# Service Bulletin

**Subject:** Pop Noise From Fuel Tank After a Cold Start or EVAP Purge Event (Equinox / Terrain)

**Models:** 2010 -2014 Chevrolet Equinox  
2010-2014 GMC Terrain

- (1) Flange location of the auxiliary fuel module (sender kit)
- (2) Primary Pump NOT the correct component to replace (module kit)

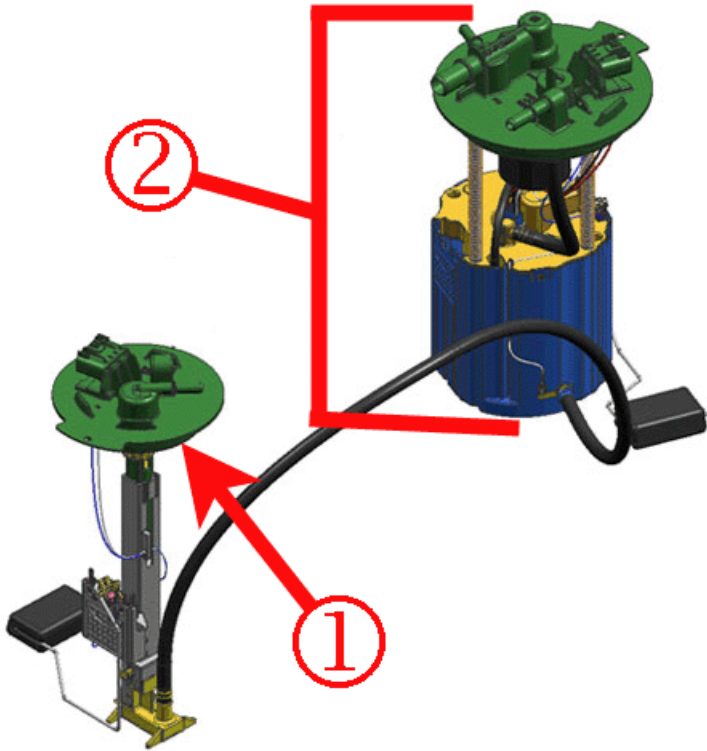
The technician should be able to duplicate the concern by commanding a purge and seal on the EVAP system using GDS2. As the vacuum reaches 3 to 5 inches, the pop/popping noise should be duplicated. The cause for this concern is the auxiliary fuel module in the left side of the fuel tank changing height (spring loaded leg).

The part number on the box of the auxiliary fuel module has not changed but the auxiliary fuel module inside of the box has. After ordering the auxiliary fuel module, remove it from the box and verify the letters "PPA" are cast into the top of the fuel module flange. This is the revised auxiliary fuel module designed to correct the pop/popping noise. The original auxiliary fuel module has "POM" cast into the flange.

**Important:** The condition described in this PI applies only to the auxiliary fuel pump module assembly. The Parts Catalog calls this auxiliary pump component the "sender kit" which is the correct part for this repair. Replacing the primary fuel pump module assembly would NOT correct this noise condition. The parts catalog calls this primary pump component the "module kit" which is the incorrect part for this repair.
